RE: WTC-C-81;
WTC-Dey Street,
Underpass; Borough of
Manhattan

In reply to your latest submittal of plans for the referenced project with a letter dated January 29, 1982, please be informed of the following comments of this Department:

SECTION G-G

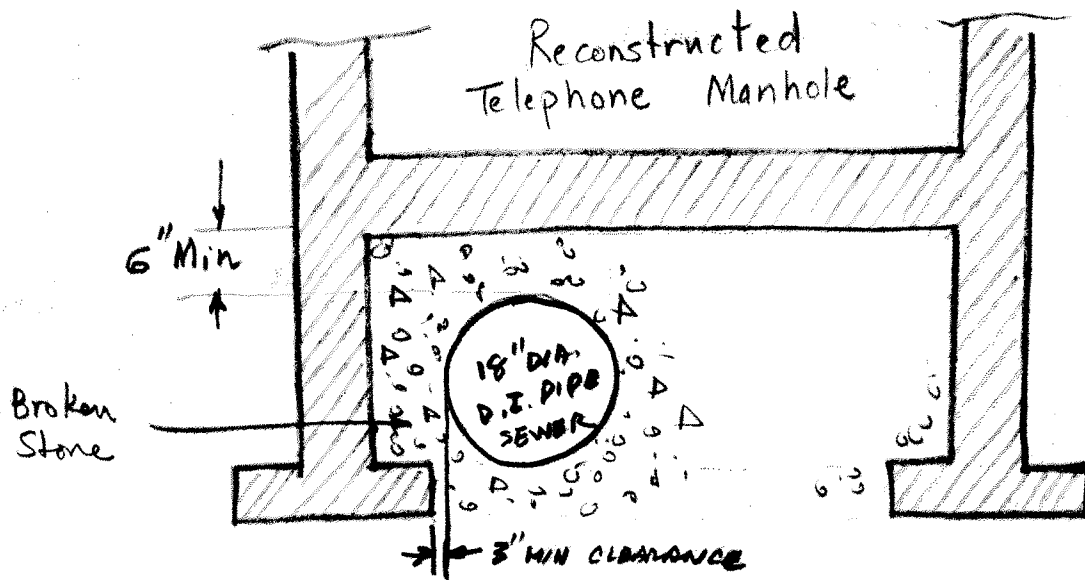
- 1) The load from the new reconstructed telephone manhole, located above the section of the proposed 18" Dia. D.I.P. sewer between manhole #3 and the existing manhole in Church Street, should be carried down to an elevation below the subgrade of the sewer, as shown in detailed section C-G. The east and west walls may be extended down and supported by continuous footings. Broken stone should be placed under and around the 18" Dia. D.I. sewer.
- 2) The section of proposed sewer between manholes #2 and 3 should be located so that its centerline is 2'-1" from the north building line of Dey Street. This same centerline clearance should be provided between the sewer and the C.D. of the 28" Dia. steam main casing.
- 3) Before final approval can be given for these plans, the details of the non-standard manholes and any other special sewer structures must be received for our review.
